SUSQUEHANNA 1/2

NRC COMMENTS

PP&L COMMENTS

2. TECHNICAL SUPPORT CENTER

Figure 8-2

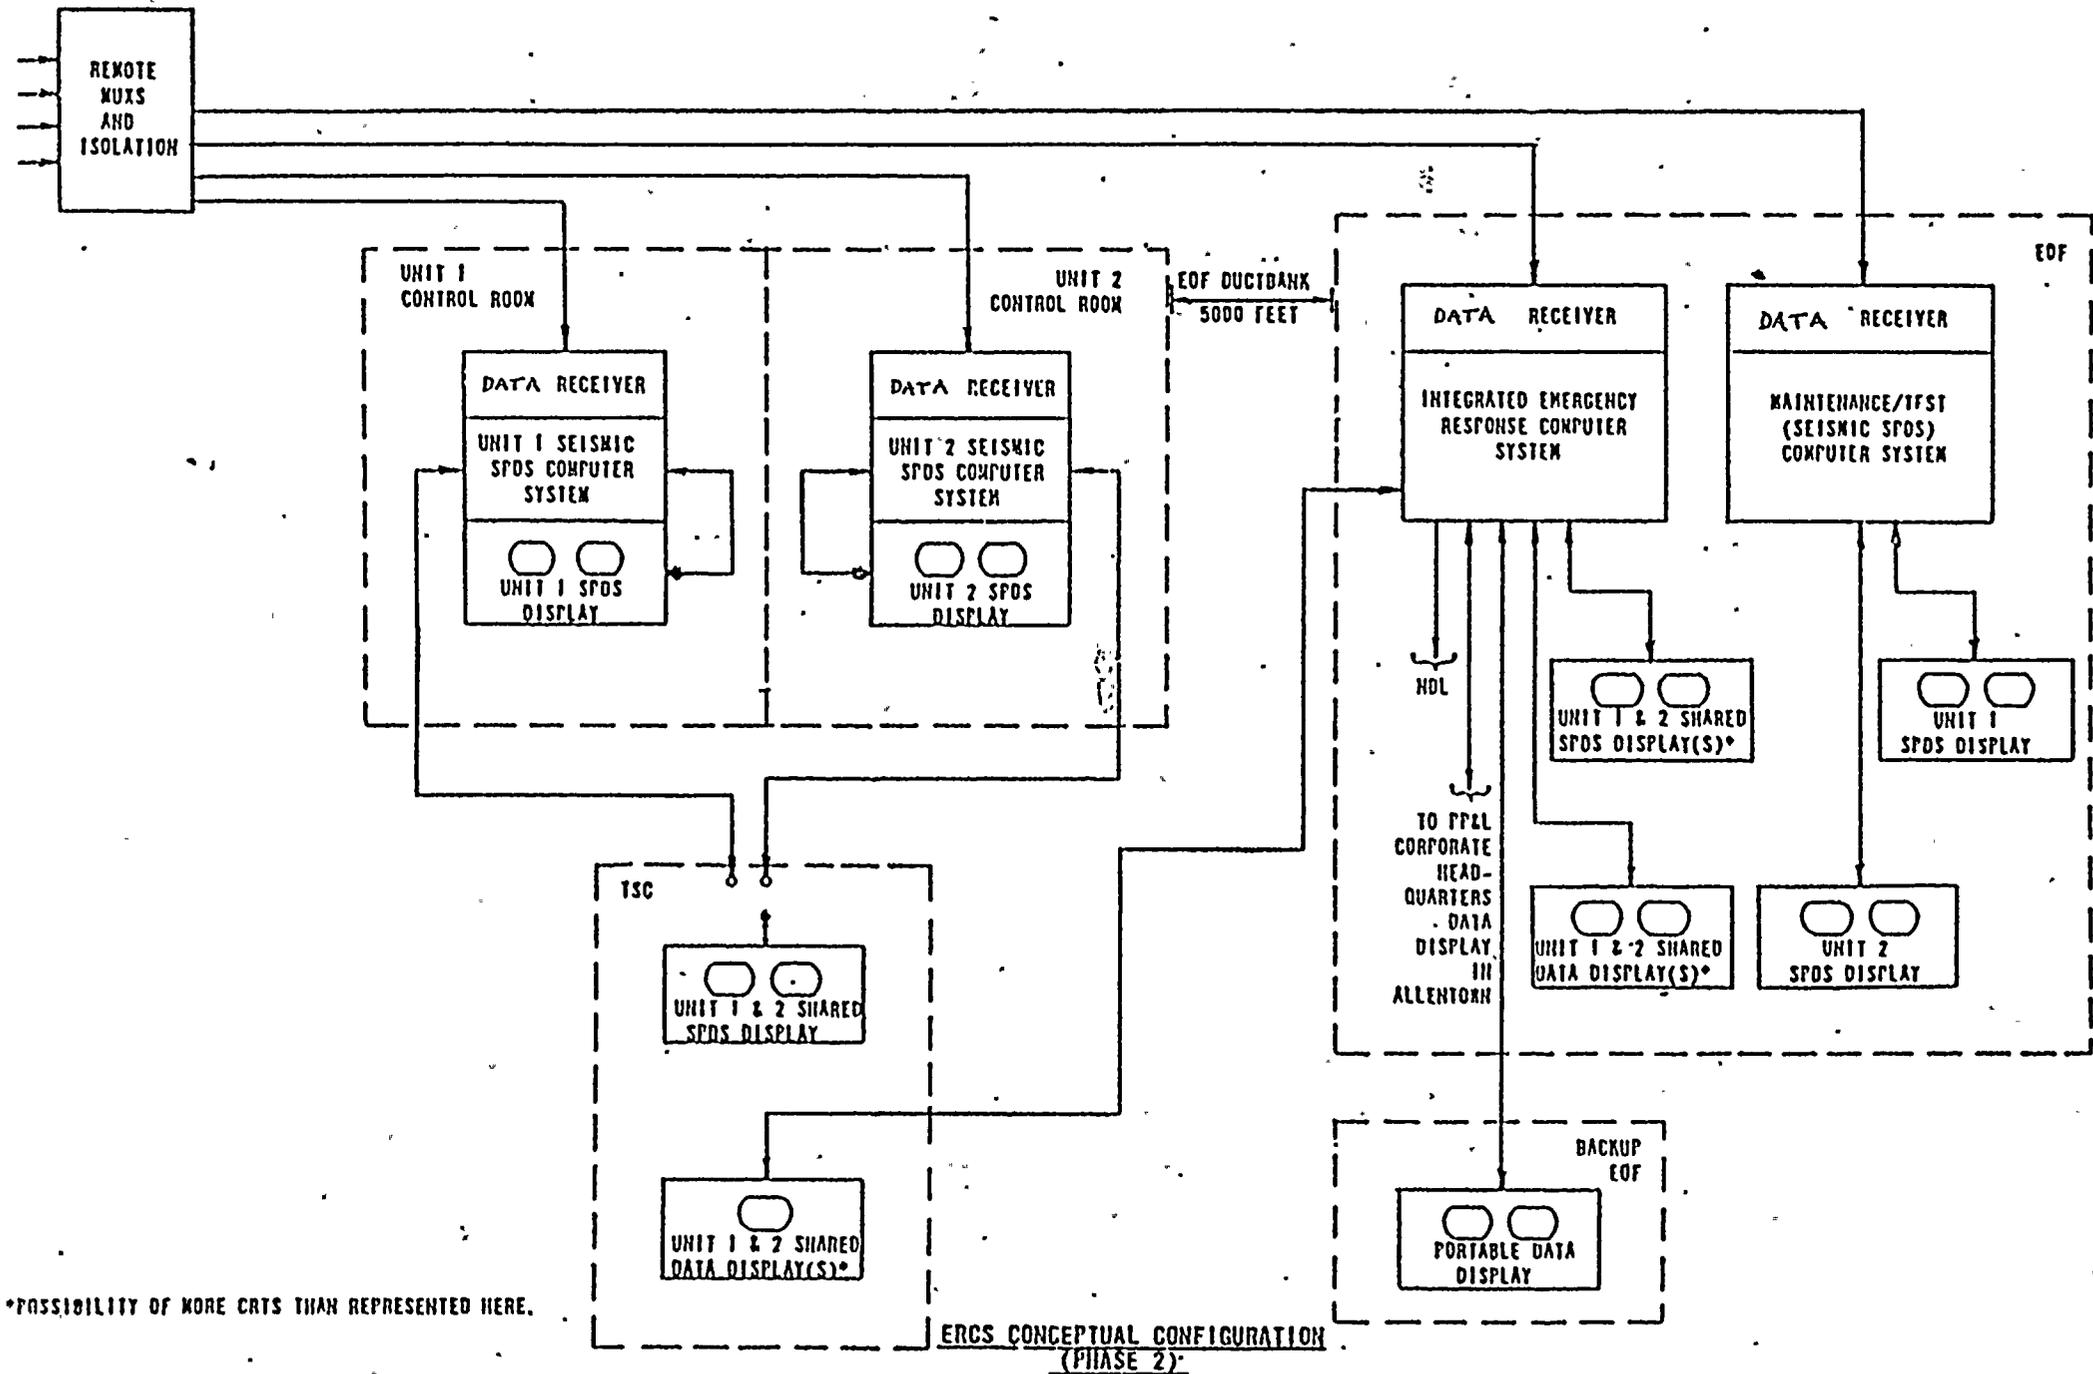
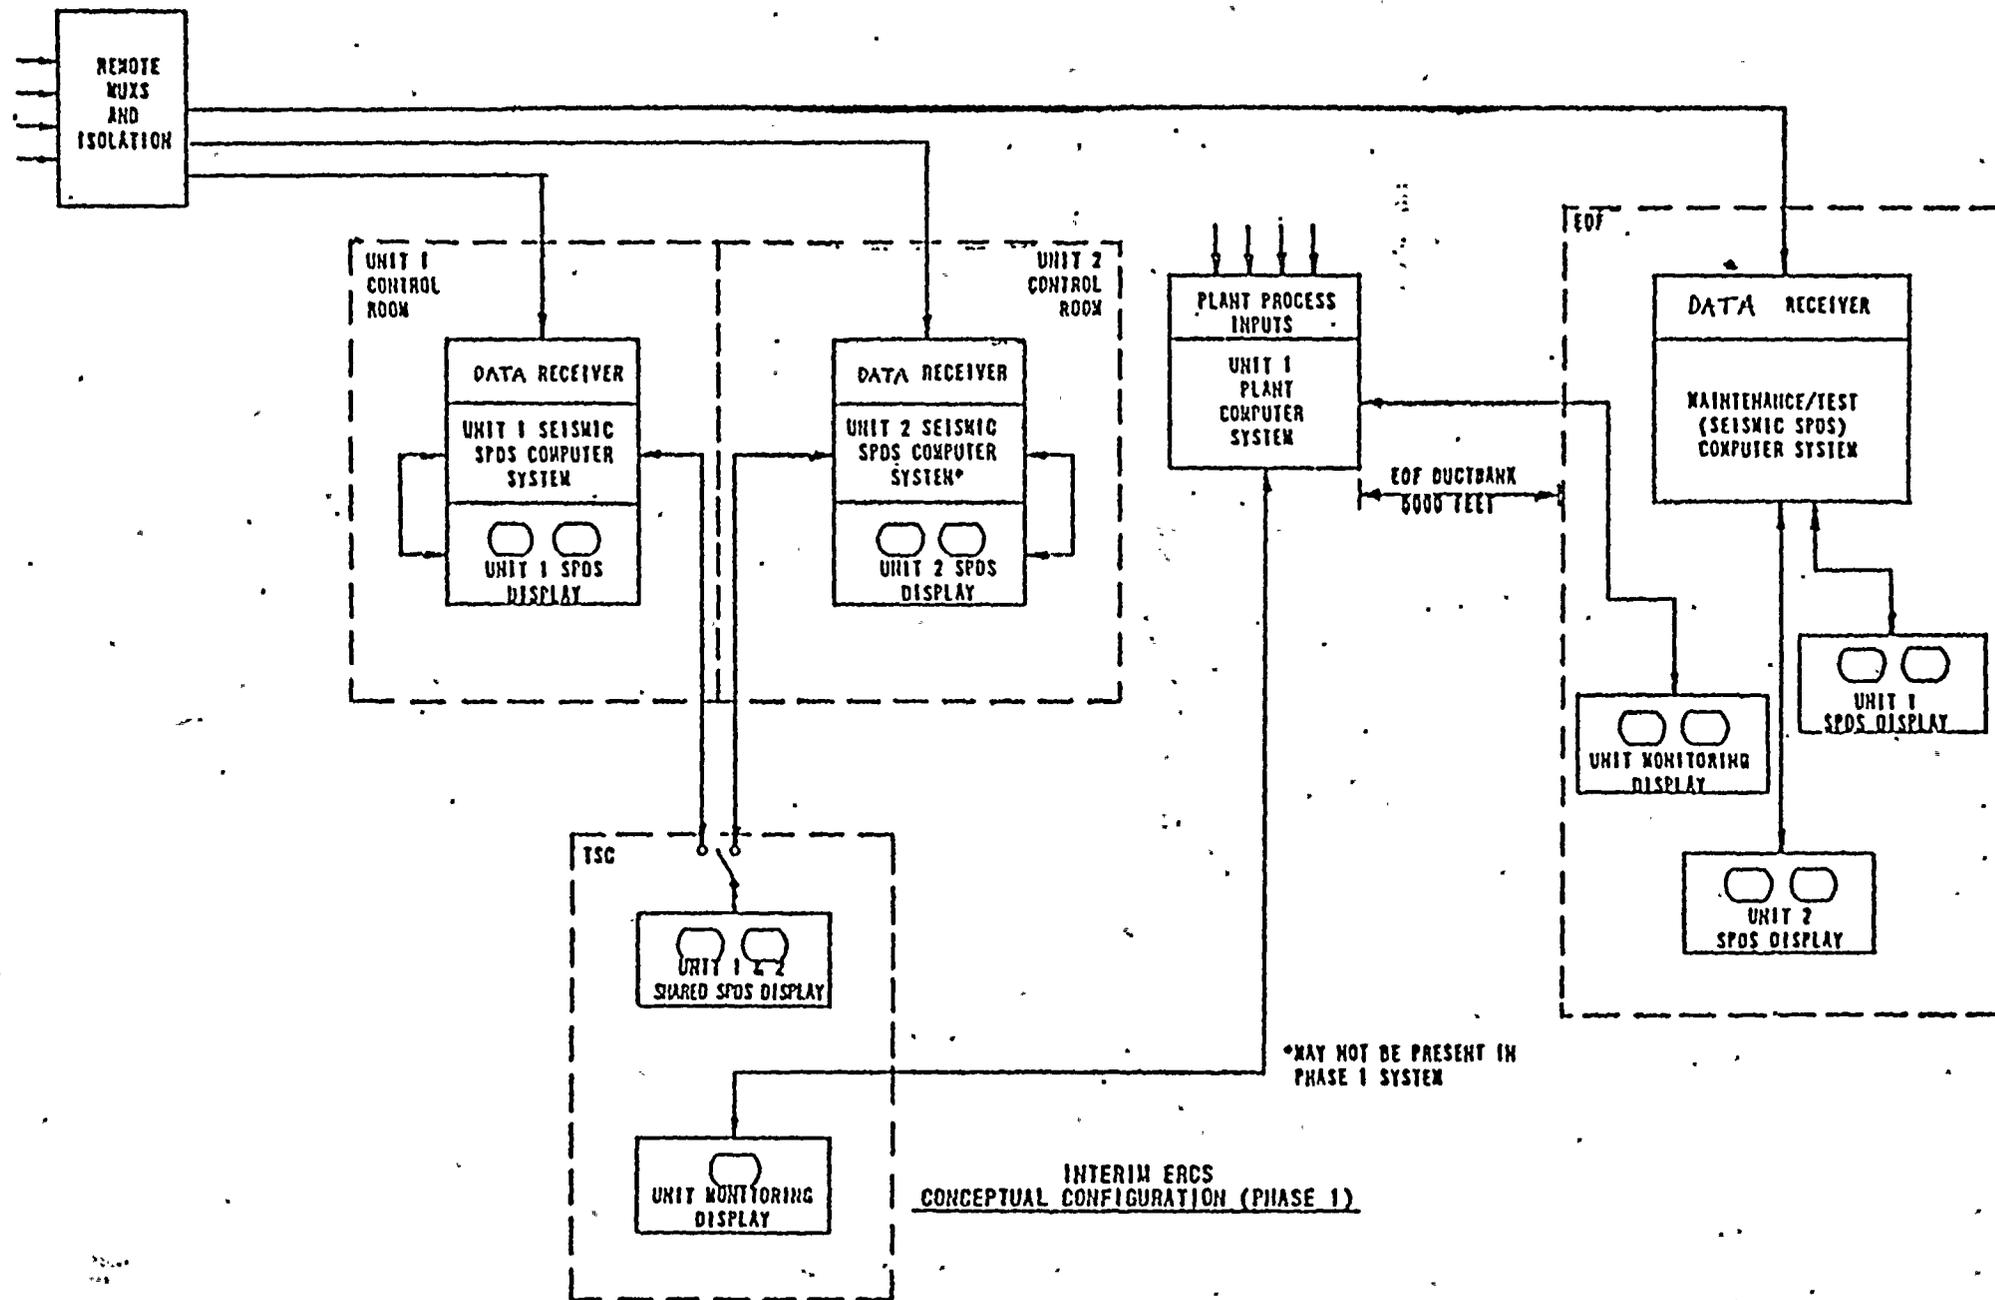
Not specified.

See Figures 8-1 and 8-2 attached.
